# Access Compliance Report

## Public Rights-of-Way

Intersection ID: 31872	Main Street: LANGDEN_GATE_DR	Cross Street: TAPESTRY_WOODS_CT	Location: SE
ADA ID: 05F18DF20CAB	Ramp Type: PerpDiag	Initial Pass/Fail: Fail	Overall Compliance: No
Severity Score: 33.75			
Codes/Mitigation Info/Possible Solution		Field Measurements/Component Compliance

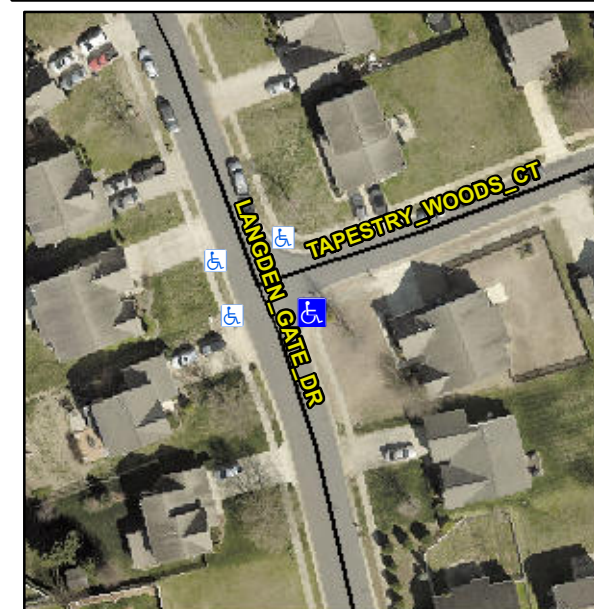
**R304.5.1, R304.5.3**

Compliance	Description	Data	Compliance	Description	Data
N/A	Ramp Length (in)	48.0	Yes	Ramp Slope (%)	5.5
No	Ramp Width (in)	41.0	No	Ramp XSlope (%)	8.5
N/A	Flare Type LT	N/A	N/A	Flare Type RT	N/A
N/A	Flare Slope LT (%)	N/A	N/A	Flare Slope RT (%)	N/A
N/A	Flare Traversable LT?	N/A	N/A	Flare Traversable RT?	N/A
N/A	Landing Length (in)	N/A	N/A	DWS Provided?	N/A
N/A	Landing Width (in)	N/A	N/A	DWS Contrast?	N/A
N/A	Landing Slope (%)	N/A	N/A	DWS Length (in)	N/A
N/A	Landing X Slope (%)	N/A	N/A	DWS Full Width?	N/A
N/A	Landing Curb? (Y/N)	N/A	N/A	DWS Offset (in)	N/A
N/A	Shared Landing?	N/A			
N/A	Gutter Ponding?	N/A	N/A	Gutter Slope (%)	N/A
N/A	Gutter Lip Ht (in)	N/A	N/A	Gutter X Slope (%)	N/A
N/A	Painted X Walk1?	No	N/A	Painted X Walk2?	No
	X Walk 1 Direction	To NW		X Walk 2 Direction	To W
N/A	X Walk 1 Width (in)	N/A	N/A	X Walk 2 Width (in)	N/A
	X Walk 1 Slope (%)	3.2		X Walk 2 Slope (%)	0.3
	X Walk 1 X Slope (%)	2.5		X Walk 2 X Slope (%)	3.5

**Remove & Replace Curb Ramp With Two New Directional Ramps or Equivalent.**
